***MODIFICATION REQUEST:
Stage 1 Mixed Commercial and
Retail Development
6 Australia Avenue, Sydney
Olympic Park
(MP 10_0168 MOD 1)***

**Modified basement car park, minor
design changes and exclusion of part
construction of East West Street**

**Director-General's
Environmental Assessment Report
Section 75W of the
*Environmental Planning and
Assessment Act 1979***

August 2013

Figure 4: Proposed Modified Layout

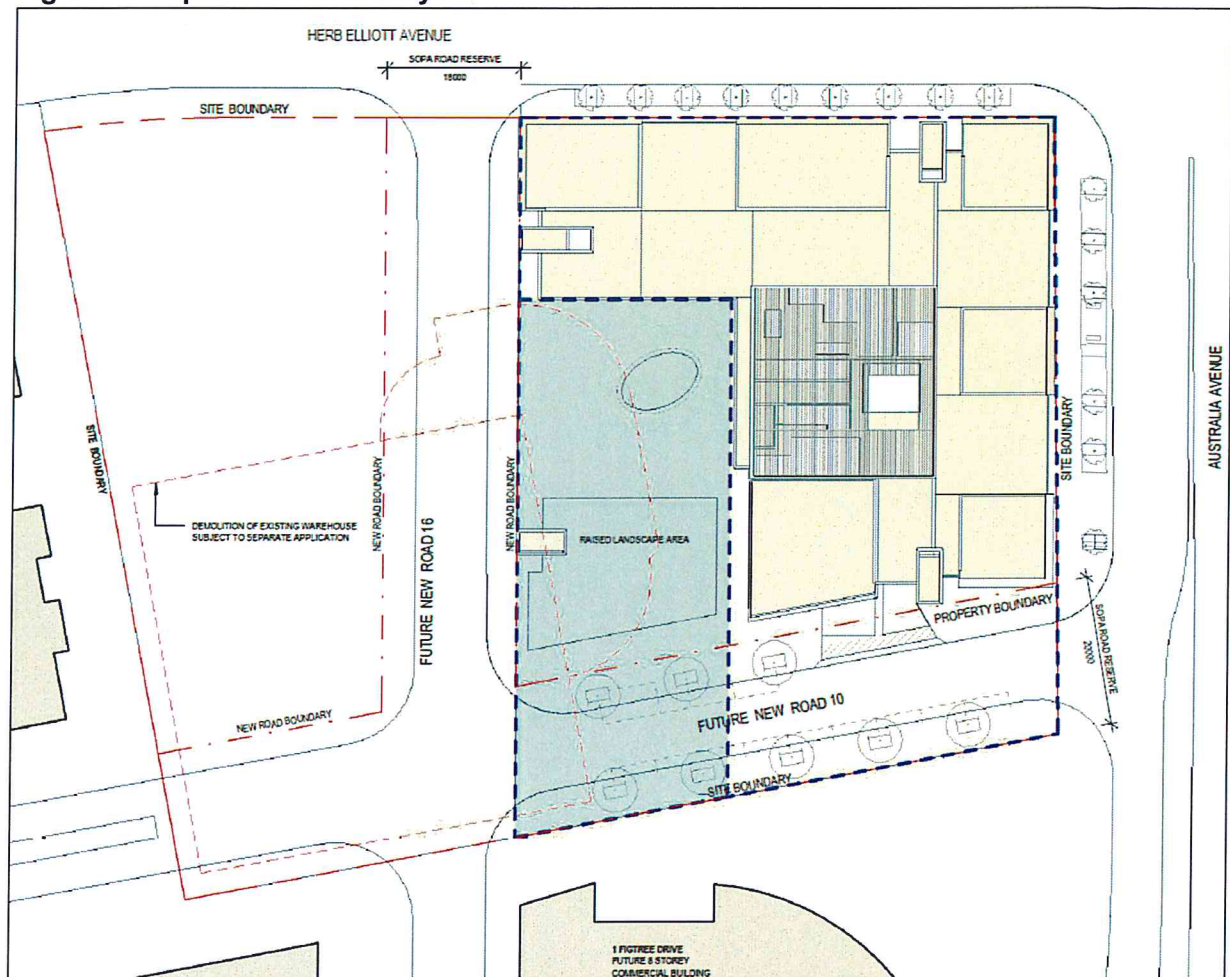
- changes to landscaping of the courtyard and undercroft area, including a landscaped area where the future Building C is to be located, as illustrated in **Figure 4**;

The proposed modifications also include a revised landscape plan which seeks to extend the paving treatment and provide a temporary grassed area where the future Building C is located given the recent approval for demolition of the warehouse building.

The revised landscape plan is also considered appropriate by the department as it provides a completed design given the demolition of the warehouse building. The central planter box and tree will soften the public plaza and provide a focal point as well as seating for the undercroft area. The temporary grassed area for the Stage 1A part of the site is also considered to be appropriate.
